UNITED STATES
DEPARTMENT OF THE INTERIOR
BUREAU OF LAND MANAGEMENT

SUNDRY NOTICES AND REPORTS ON WELLS
Do not use this form for proposals to drill or to re-enter an abandoned well. Use form 3160-3 (APD) for such proposals.

5. Lease Serial No. NMLC037777A
6. If Indian, Allottee or Tribe Name
7. If Unit or CA/Agreement, Name and/or No.
8. Well Name and No. LEVERS 5
9. API Well No. 30-015-22443-00-S1
10. Field and Pool or Exploratory Area GRAYBURG JACKSON-SR-Q-GRBG-S
11. County or Parish, State EDDY COUNTY, NM

**** BLM REVISED ** BLM REVISED ** BLM REVISED ** BLM REVISED ** BLM REVISED ****

Author:	BCM & Associates, Inc	Well No.	#5
Well Name	Lavers	API #:	30-015-22443
Field		Lease/ID#	
County	Eddy	Zone:	Grbg Jackson
State	New Mexico		660'FWL & 660'FSL
Spud Date	2/12/1978		Sec 33, T16S, R29E
GL	3602'

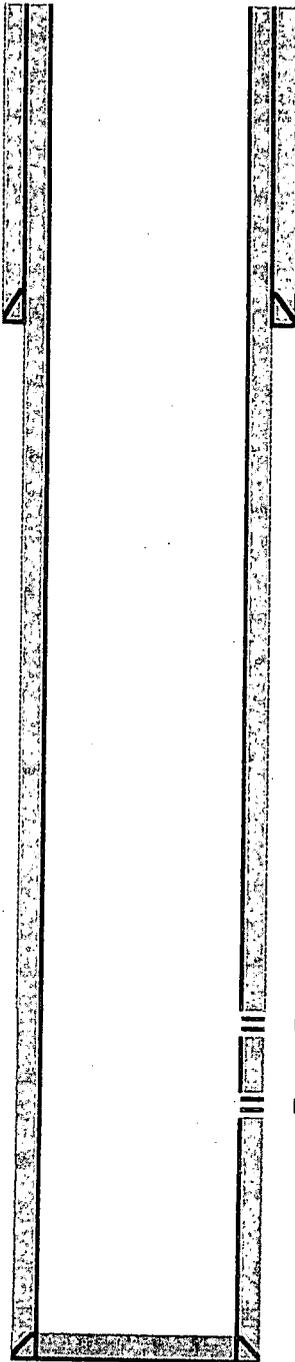
EST	ACT
Surf.	270	430
Yates	860	862
7R	1090	1095
Qu	1650	1652
GB	2150	2002
Pie	2430	2478

5 1/2 15.5# CSG @ ~~2,530~~ 2551
 Hole Size: 7 7/8

Author:	BCM & Associates, Inc	Well No.	#5
Well Name	Levers	API #:	30-015-22443
Field		Lease/ID#	
County	Eddy	Zone:	Grbg Jackson
State	New Mexico		660'FWL & 660'FSL
Spud Date	2/12/1978		Sec 33, T16S, R29E
GL	3602'

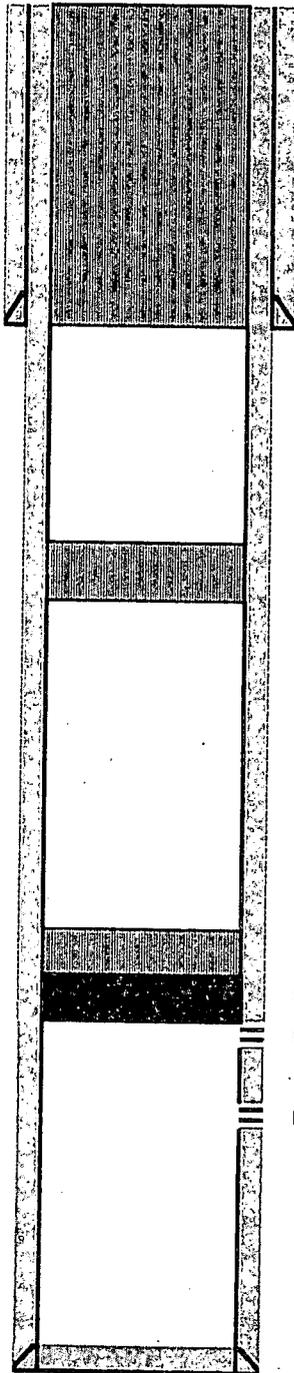
3. Spot 40 sx cmt @ 352'-Surface.

2. Spot 25 sx cmt @ 730-530'. WOC & Tag (B/Salt)

1. Set 5 1/2" CIBP @ 2210'. Circulate hole w/ MLF. Pressure test csg. Spot 25 sx cmt @ 2210-2010'
